FINAL CLOSURE & RECLAMATION PLAN

BLAZON No. 1 MINE

Re: North American Equities Final Closure and Reclamation Plan,
Blazon No. 1 Mine (ACT/007/021)

BLAZON NO. 1 MINE
FINAL CLOSURE AND RECLAMATION PLAN

FIGURE 3

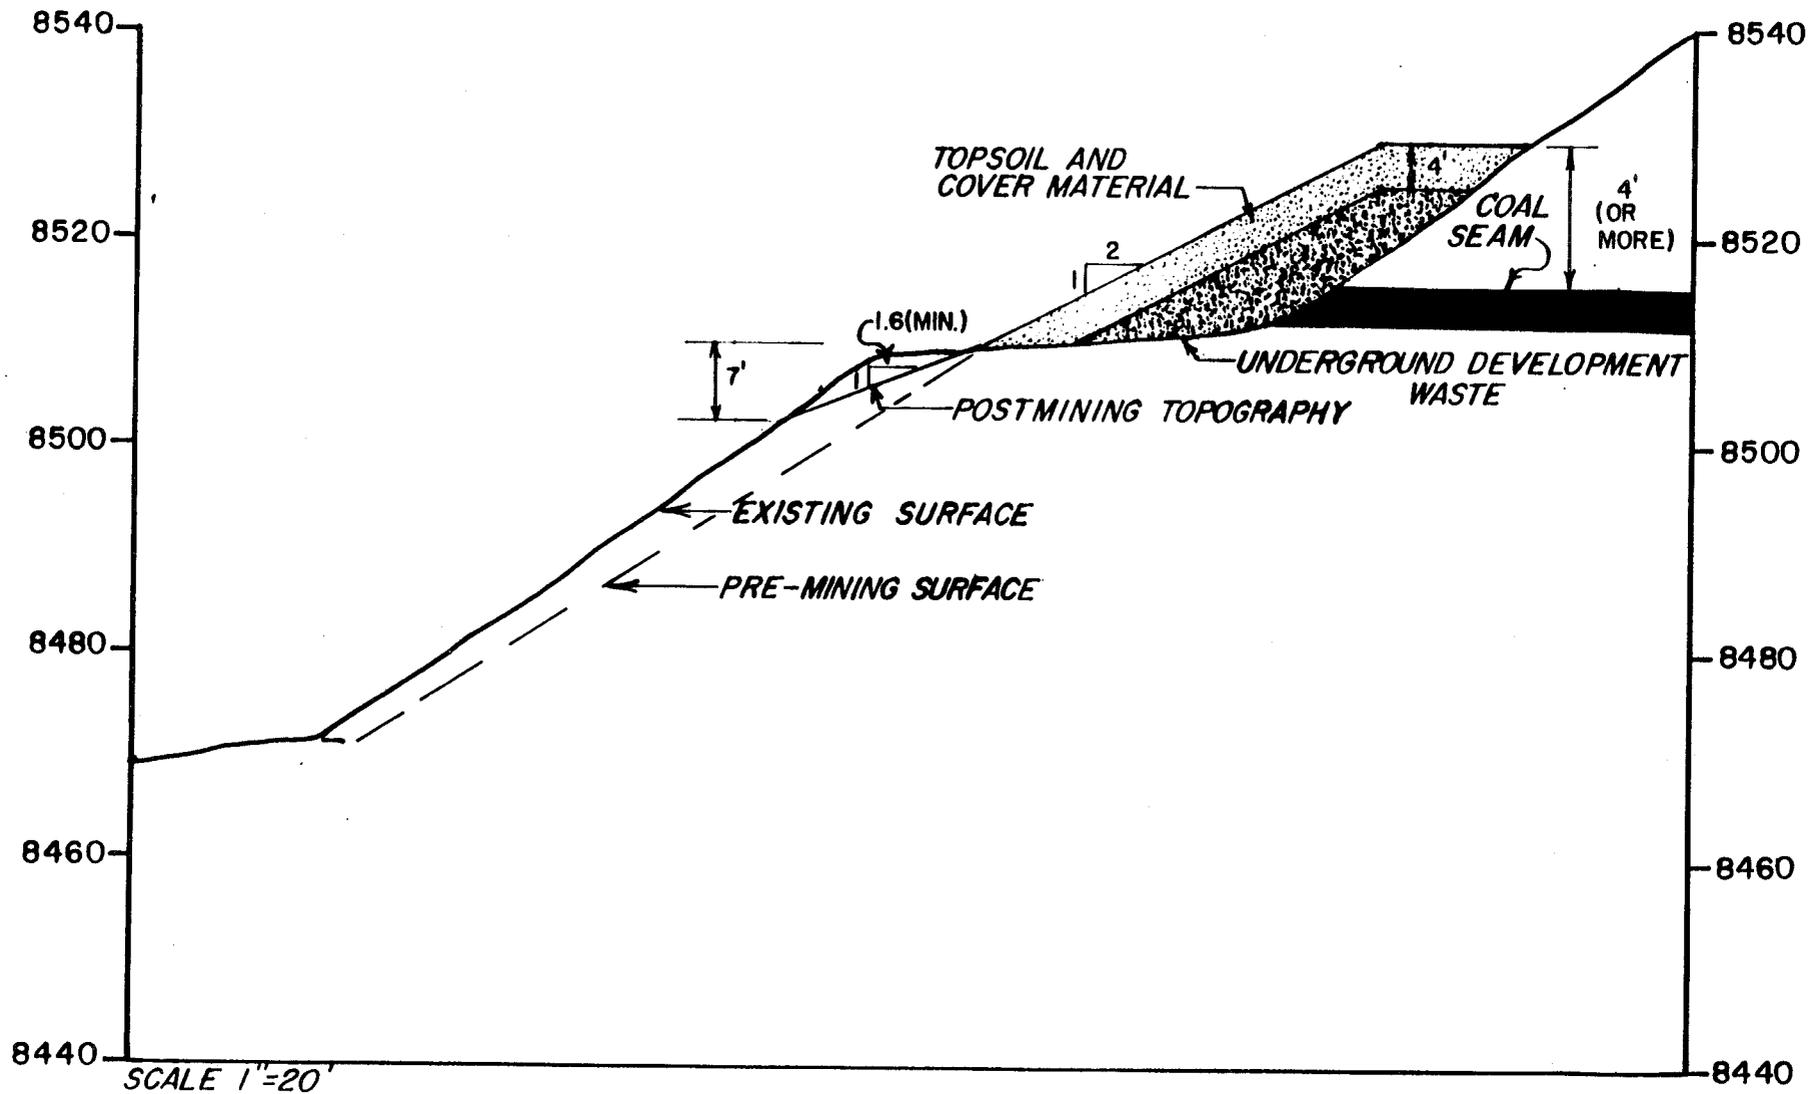
The applicant has requested a change in the depth of the fill material that will cover the underground development waste from four feet to one foot. The Division has denied the request for the change of cover depth from four feet to one foot. This decision is based on the information presented in Exhibit 15 and Oct. 5, 1985 correspondence. This material is classified as an acid and toxic-forming material. An acid-base potential less than -5 tons of CaCO₃/ 1000 tons of material is determined to be an acid- and toxic- forming material. The submitted underground development waste analytical data has an acid-base potential between -6 and -8.7 tons of CaCO₃/ 1000 tons of material. This acid- and toxic- potential may be alleviated with the application of 9 tons of a fine mesh limestone to the underground development waste. The CaCO₃ must be thoroughly mixed with the underground development waste material prior to burial.

NAE has requested that the amount of cover material over the underground development waste be reduced from four (4) feet to one (1) foot, based on the analyses presented in Exhibit 15. In the event that UDOGM approves a reduction in cover thickness, the calculations and quantities of cover material will be in accordance with the approved change.
